### **ADDENDUM NO. 1**

**To: ALL PROPOSAL HOLDERS**  
**FINANCIAL ITEM NUMBER: 42215127285**  
**CONTRACT NUMBER: E3X68-R0**

DESCRIPTION: Work Document-Driven Contract consist of providing all labor, materials, equipment, and incidentals necessary for maintenance of the Bold Landscape sites in Franklin, Gadsden, Jefferson, Leon, and Wakulla Counties as specified and outlined in the Contract Documents.

**APPENDIX A: BOLD LANDSCAPE LOCATIONS**

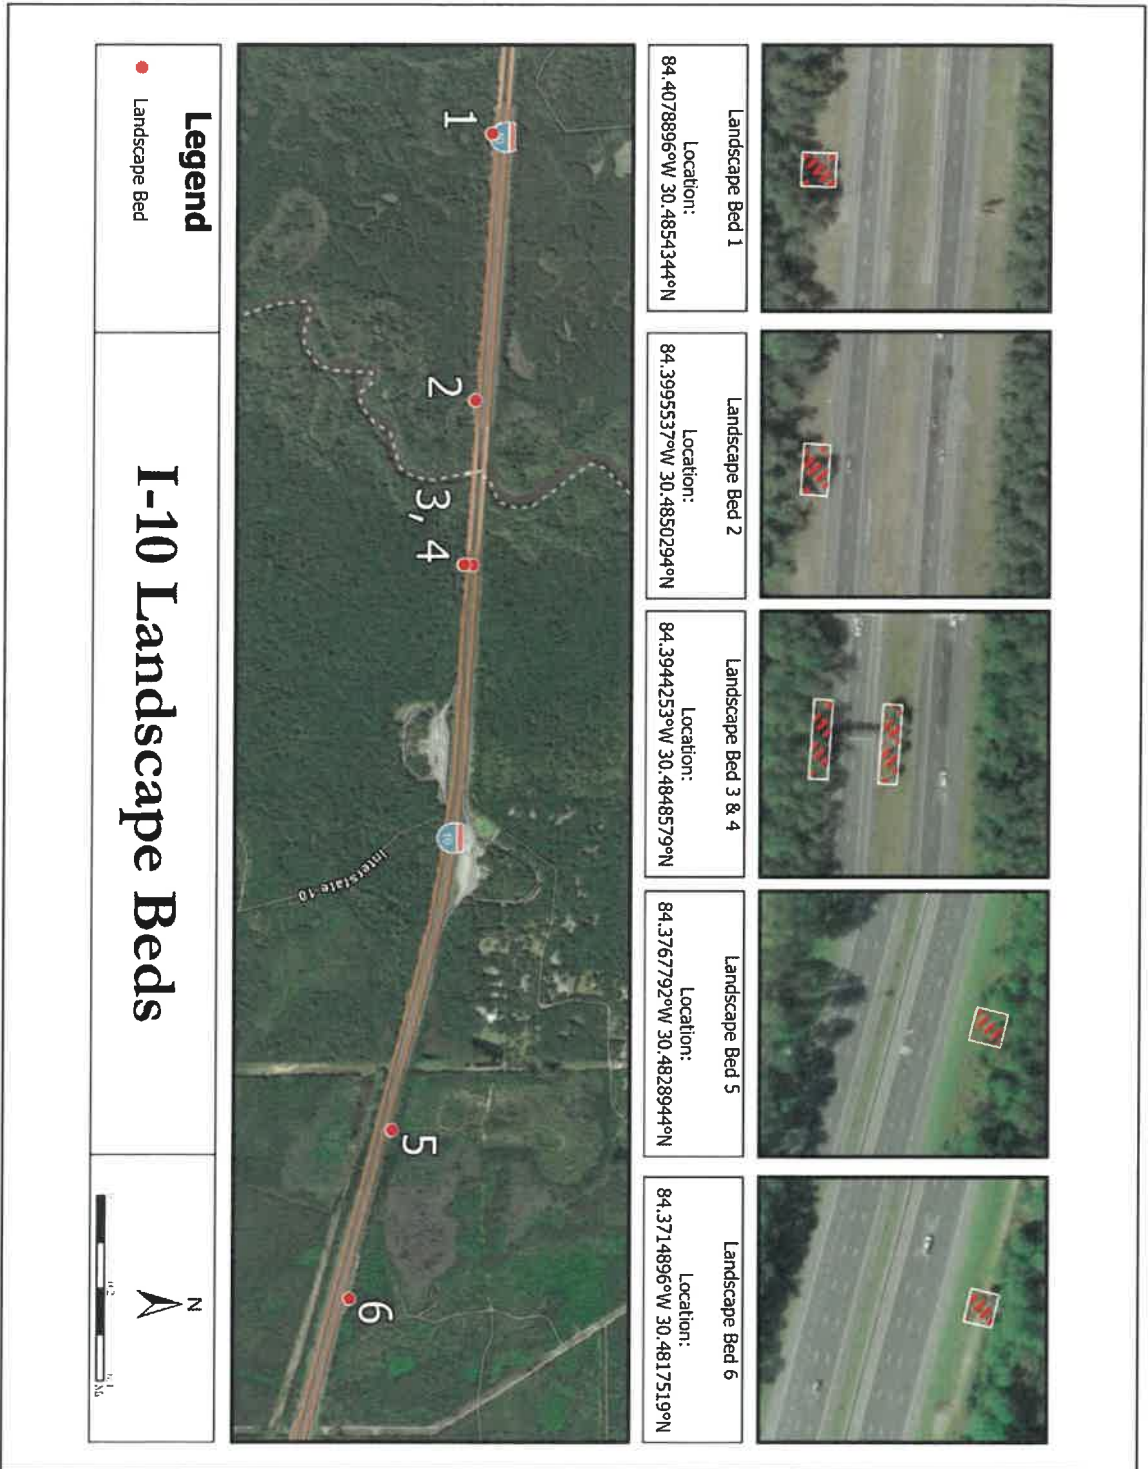
**-Page 50: Inserted new sheet; expands Appendix A as referenced on page 49, foot note #3.**

<sup>3</sup> Landscape beds to be serviced under this contract are referenced and illustrated in the Appendix as I-10 Landscape Beds. Landscaping within EB & WB rest area corridors is maintained under a separate contract (Contract #: E3V79)
